## STATION SYSTEMS - POWER SUPPLY

### INSTALLATION AND MAINTENANCE

- This addendum supplements Section C70.026. It is issued to add voltage requirement information when associating 1A KTS with a 555 PBX. It also covers general information and some restrictions for equipment installed in the city of San Francisco.

Fig. 1A

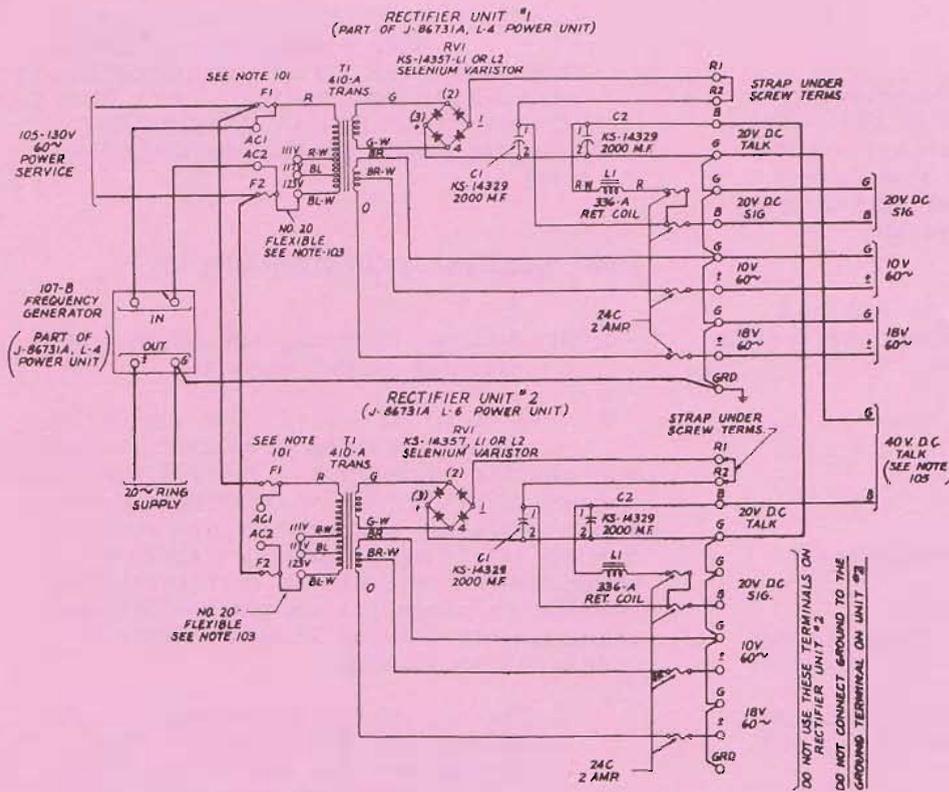
- Whenever additional voltage is required to operate 1A key telephone systems (50 type KTU, 1A KTU but not 1B KTU) associated with 555 PBX equipment, arrangements as shown in Fig. 1A (Dwg. H3075) may be used.
- In areas where the commercial power supply is considered satisfactory, an occasional interruption should not cause serious complaint as partial service can be provided through night connections. If the power supply is not reasonably dependable, the use of a power unit without batteries would not be feasible. At hospitals, police departments and similar vital services, any service interruption should be avoided; therefore, battery reserve should be provided.

- 101 FUSES (F1) AND (F2) SHOULD BE MDL 2 FUSETRONS
- 102 LEADS NOT FURNISHED WITH APPARATUS SHOULD BE 20 AWG SOLID.
- 103 THE TAP ON THE PRIMARY OF THE POWER TRANSFORMER SHOULD BE CONNECTED TO A TERMINAL WHICH WILL LIMIT THE TALKING BATTERY OUTPUT TO A MAXIMUM OF 50 VOLTS.
- 104 REPLACE THE K2 LAMPS WITH 2Y LAMPS WHEN THIS RECTIFIER ARRANGEMENT IS USED.
- 105 WHEN THIS ARRANGEMENT IS USED WITH ONE POSITION OF 555 PBX, REPLACE THE 2 AMP 24C FUSES IN THE 20V TALK CIRCUITS WITH 1 1/2 AMP 24G FUSES. WHEN USED WITH TWO POSITIONS OF 555 PBX, LEAVE THE 2 AMP FUSES IN PLACE IN THE RECTIFIER, BUT FUSE THE BATTERY SUPPLY LEADS TO EACH POSITION WITH 1 1/2 AMP FUSES.
